ENGINE - SECURING FEATURES - HP COMPRESSOR CASES - REVISED BOLTS FOR FJ FLANGE BRACKETS
- CATEGORY CODE 6 - MOD.ENG-72-0215

V2500-ENG-72-0215

SERVICE BULLETIN

View on flange 'FJ' Looking forwards
Fig.1

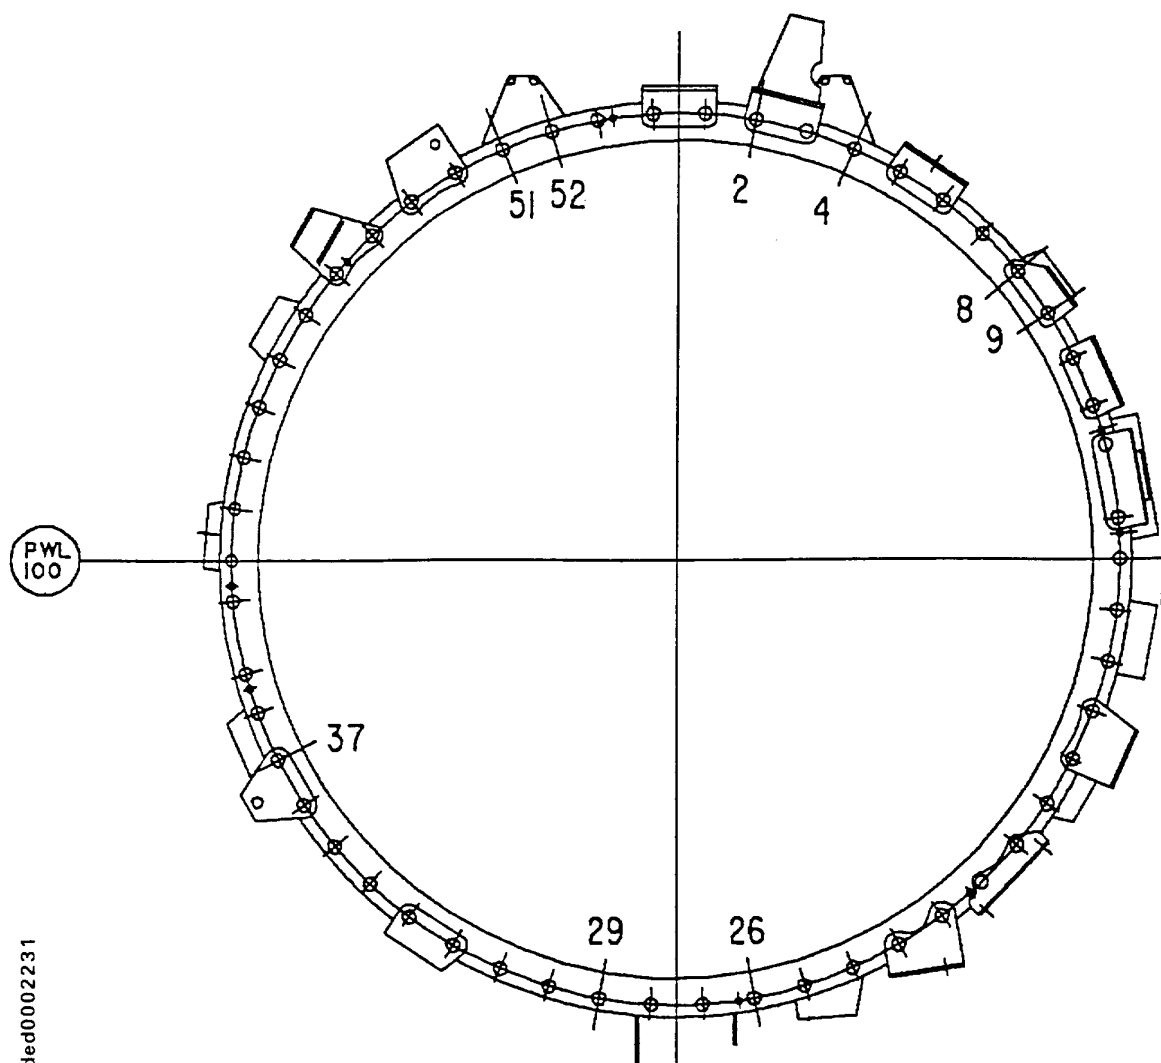
At different positions on flange FJ, bolts that attach brackets do not have a sufficient threaded part. These bolts do not obey the V2500 standard specification.

- (i) The length of the bolts at positions 2, 8, 9 and 37 is increased.
- (ii) The length of the bolts at positions 4, 26, 29, 51 and 52 is decreased.

AT HOLE POSITIONS 4,26,29,51 AND 52 AS2III4 REPLACES AS2III7
AT HOLE POSITIONS 2,8,9 AND 37 AS2III7 REPLACES AS2III4

For the correct procedures to replace the affected bolts, refer to the Engine Manual (EM), Chapter/Section, 72-41-00, Assembly-02.
